DEVELOPMENT REVIEW BOARD REPORT

Meeting Date: May 3, 2018 Item No. 3
General Plan Element: *Character and Design*
General Plan Goal: *Foster quality design that enhances Scottsdale as a unique southwestern desert community.*

Bell Group Self Storage 50-DR-2017

Location: 10501 North 116th Street

NORTH ELEVATION

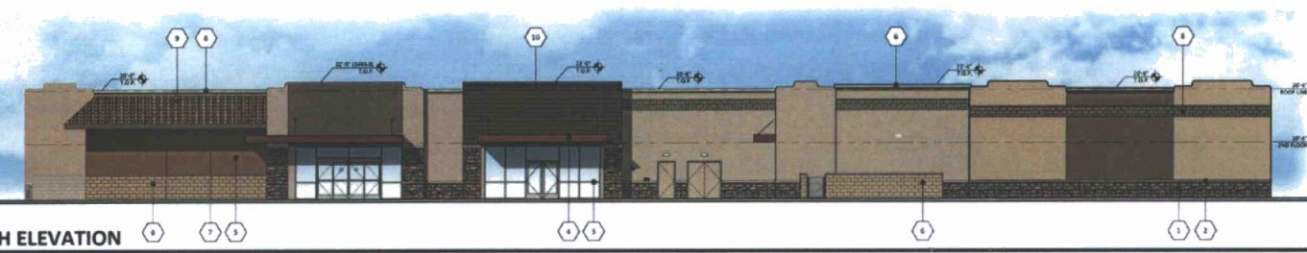
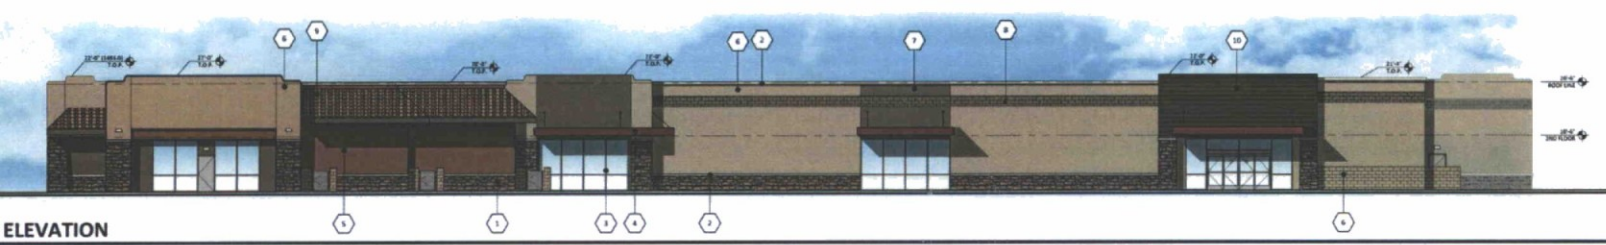
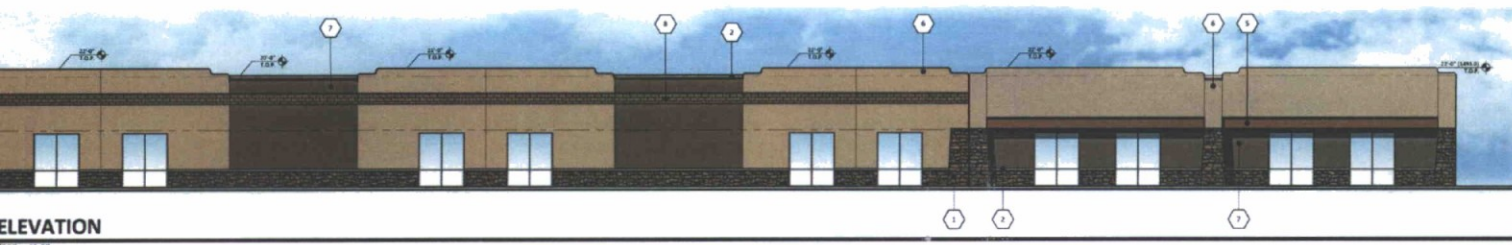
- **Building Massing:** The applicant shall provide building elevations and details which demonstrate that the building is designed in a way to minimize the illusion of long walls, specifically on the east and north building elevations, subject to Development Review Board approval.

Staff analysis: The proposed building incorporates steps in the north and east wall planes to divide the longer walls. In addition, other design elements such as windows, awnings, and columns are integrated into the elevation to add interest and interrupt the wall planes.

LANDSCAPE PLAN

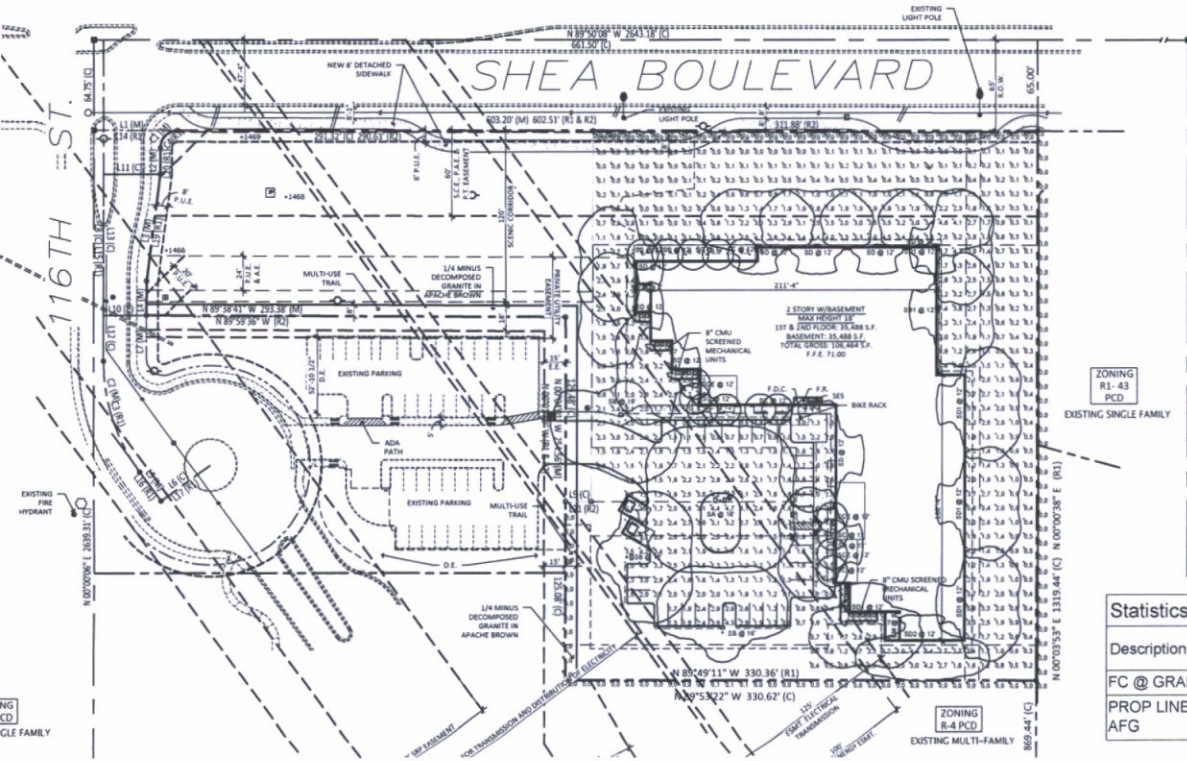
Staff analysis: The submitted landscape plan proposes a densely planted row of thirty-one *Acacia salicina* (Willow Acacia) trees. This species will do well to quickly provide a visual buffer for the adjacent residential development. Included in the Development Review Board stipulations is a requirement that the trees be a minimum 3-inch caliper specimen upon installation, which meets the Zoning Ordinance requirement of mature.

- C. With the final plan submittal, the applicant shall revise the landscape plan so the 31 proposed Willow Acacia trees along the east property line are a minimum 3" caliper at installation, to be considered "mature" as defined by the zoning ordinance.

7. Prior to final plan submittal, the owner shall submit a revised landscape plan for staff review and approval, which replaces up to 50% of the proposed willow acacia trees with southern live oak trees within the landscape buffer along the east property line.
